Review of Evergy Metro and Evergy Missouri West 2024 Integrated Resource Plan

By: Chelsea Hotaling, Energy Futures Group
Anna Sommer, Energy Futures Group
Ivan Urlaub, The Council for the New Energy Economics

On behalf of The Council for the New Energy Economics ("NEE")

August 29, 2024

Figure 1. Metro Market Prices⁴⁶

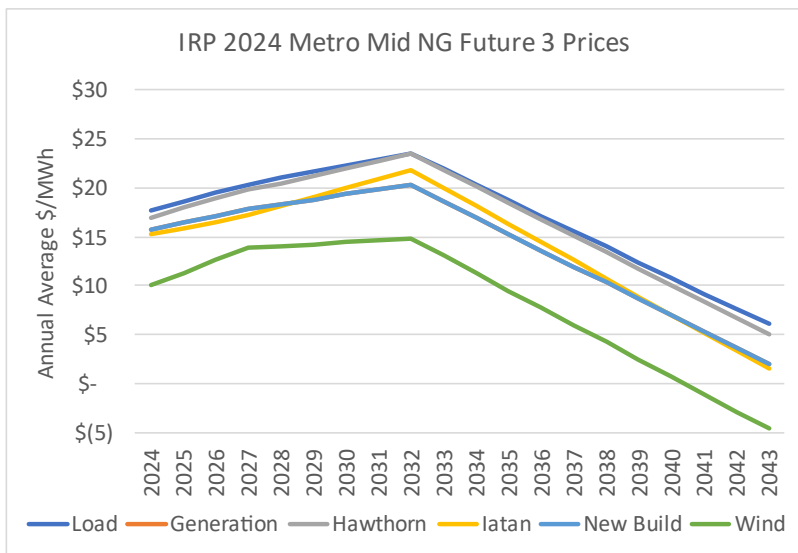
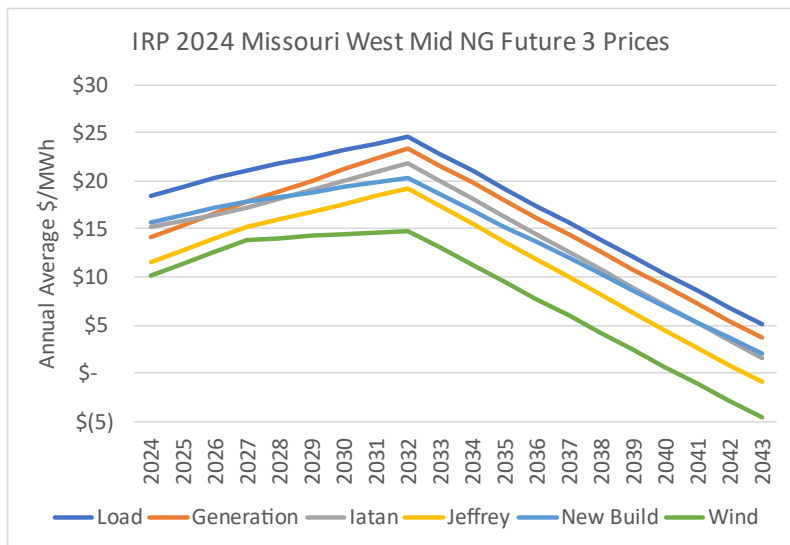
Figure 1 and Figure 2 show the market prices modeled for Evergy Metro and Evergy Missouri West, respectively, under the SPP Future 3 scenario. Given the decline in pricing throughout the planning period, it would be helpful to understand if congestion is the main cause of the negative prices, or if the negative pricing is caused entirely from the level of renewable

buildout under SPP Future 3 and the PTC impact from those resources. We ask that Evergy consider evaluating a market price forecast where transmission upgrades are assumed to be included, in order to see what the impact to the market price forecast is. If the impact is significant, then we ask that Evergy consider including this as a sensitivity in future modeling.

Figure 3. Evergy Natural Gas Price Forecast⁴⁸

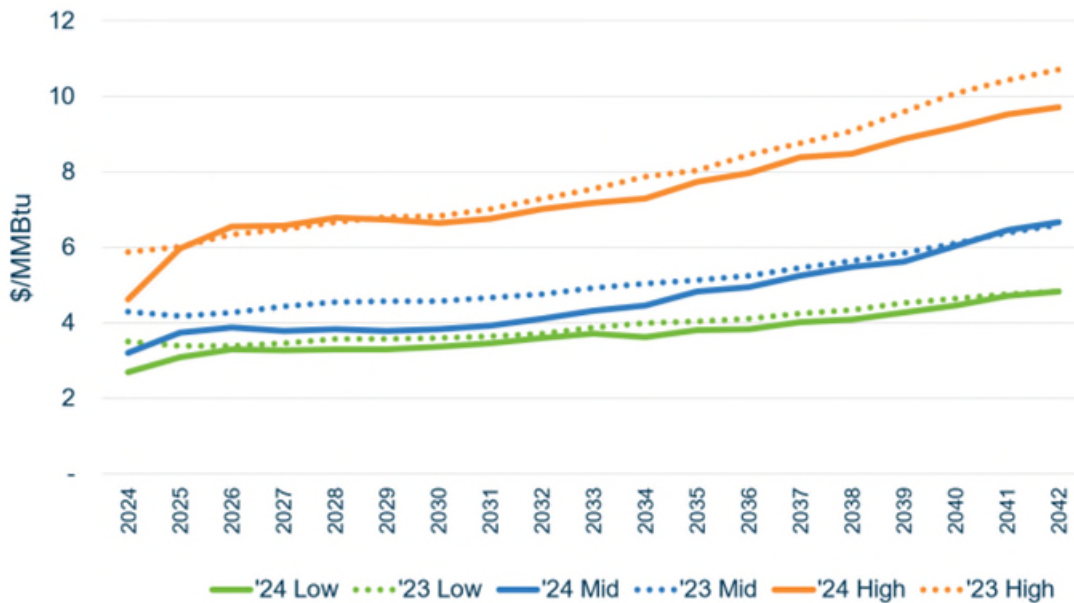
Figure 3 below shows the comparison of the natural gas price forecasts modeled for the 2023 IRP Update and the 2024 IRP. This figure shows that the entire gas price forecast horizon shifts up or down by multiple dollars per MMBtu each year in reaction to the most recent 12 months. This shift between 2021, 2023, and 2024 indicates that inevitable future fuel price volatility and prolonged periods of higher price are not incorporated into the gas price forecast methodology.

NEE would like to discuss in more detail during the stakeholder process with Evergy what risks Evergy is incorporating, which they may be understating, and potential methodologies to more accurately anticipate the inevitable occurrence and effects of acute and prolonged periods of elevated gas prices and more volatile gas prices into the Company's natural gas fuel price forecast. Our objective is to arrive at a forecast method that will facilitate more accurate modeling of gas fuel prices over the entire planning horizon and improved resource selection and accuracy of anticipated costs.

Figure 5. Round Trip Modeling Process⁵⁵

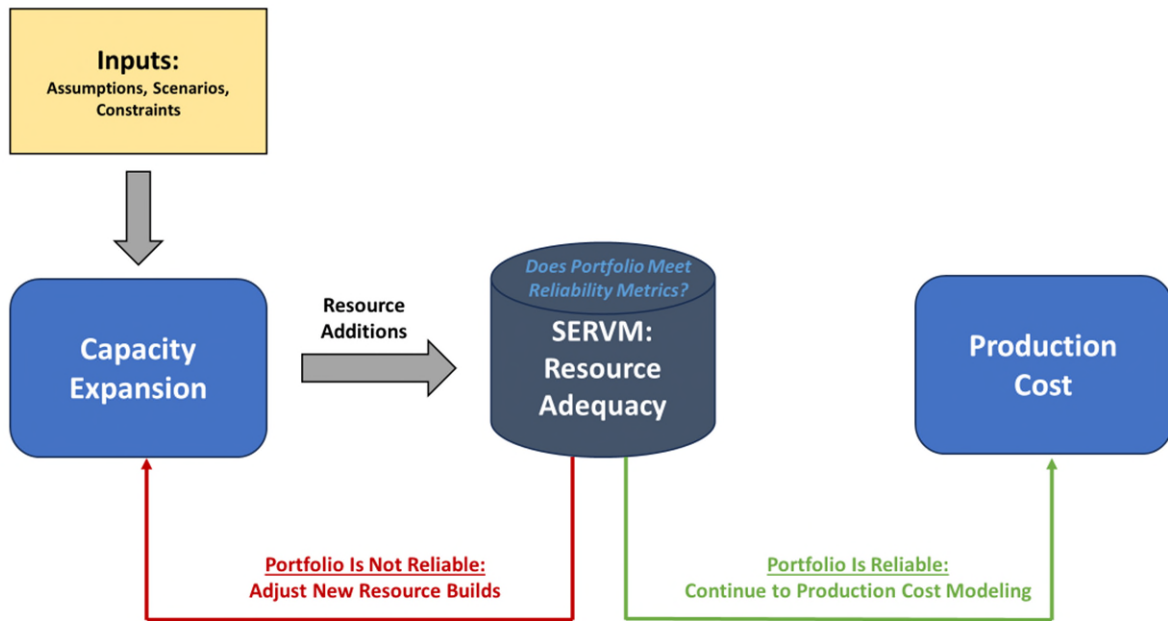
These results show that approximately 97% of the EUE is occurring in the summer months of June to August. We recommend that Evergy close the loop between its SERVM and PLEXOS modeling and explore making portfolio changes to address outcomes such as these. For example, could a different mix of renewable and storage resources improve the LOLE of the plan? I.e., a larger amount of solar (and potentially storage) given the identified summer risk in this portfolio. Additionally, would the results change if some of the four-hour battery storage resources were modeled as longer duration, such as six- or eight-hour batteries? Only four-hour battery storage resources were modeled in PLEXOS and it would be important to understand whether or not SERVM sees additional value for longer duration resources that is not visible to PLEXOS. This information would help inform what battery duration should be included in the PLEXOS capacity expansion modeling.

Figure 5 below illustrates an example of a Round-Trip modeling process⁵⁴ where capacity expansion portfolios are then passed to a resource adequacy model, such as SERVM. If the portfolio is reliable then it is then passed to the production modeling step. However, if the portfolio is not reliable, changes are made in the capacity expansion step (i.e. including

additional resources, switching resources in the mix, moving to longer duration storage) are implemented to address the shortfall events and then the portfolio will be rerun through the resource adequacy modeling. This process continues until the portfolio is reliable.
